DEPARTMENT OF THE AIR FORCE
DAVID GRANT USAF MEDICAL CENTER (MAC)
TRAVIS AIR FORCE BASE, CALIFORNIA 94535

SUBJECT: Radiation Survey Report dated May 31, 1984 License #04-07840-02
NRC Control No. 17711

TO: US NRC (FCMLB:FAS)
Washington D.C. 20555

ATCH 1

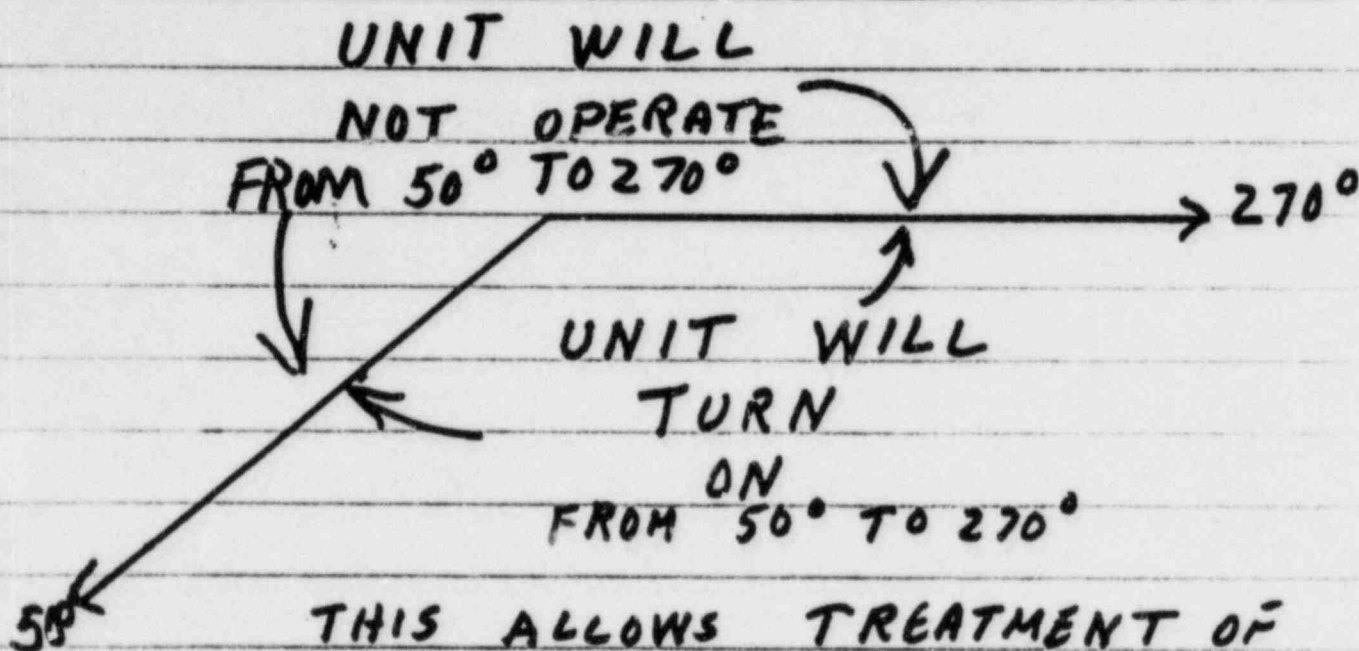
b. When operating in the fixed mode and the primary beam not directed toward the beam stopper, then the unit has interlocks so that the unit will only be turned on when the unit is directed toward the floor or the east wall. (see atch 1)

c. During the survey, the intrlocks were checked by moving the primary beam off the beam stopper and trying to use the rotational or arc mode. The unit would not turn on indicating the interlock was operational. Then the unit was checked by putting the unit in fixed mode and checking the location where the unit would operate. The unit operated in areas indicated on atchl and would not operate in other areas.

DGMC
RAVIS AFB, CA
NRC Control 17711

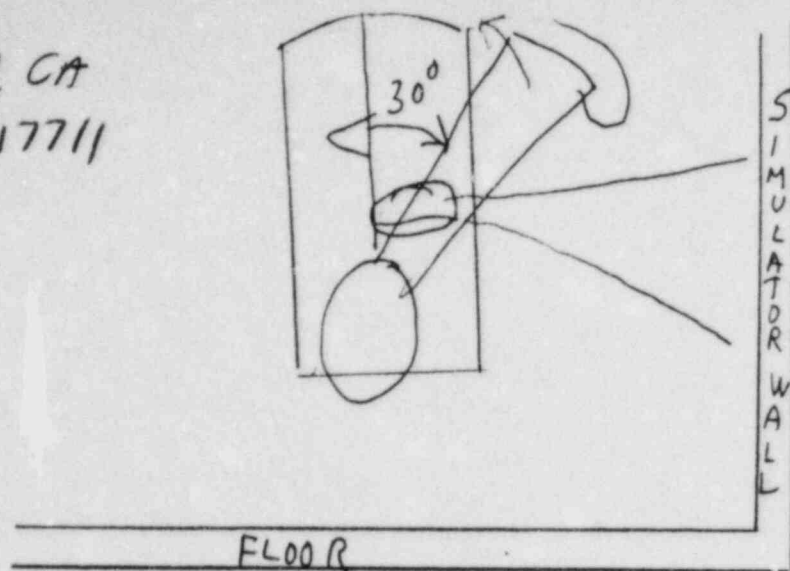
d. The maximum readings with the unit in rotational mode are shown in atch2. Measurements were made with a 10x10 fiel with phantom in place.

e. When the unit is operated with the primary beam not directed toward the beam stopper, the measurements were made in the most adverse condition with the beam directed toward the east wall and the measurements made in the corner of the room.
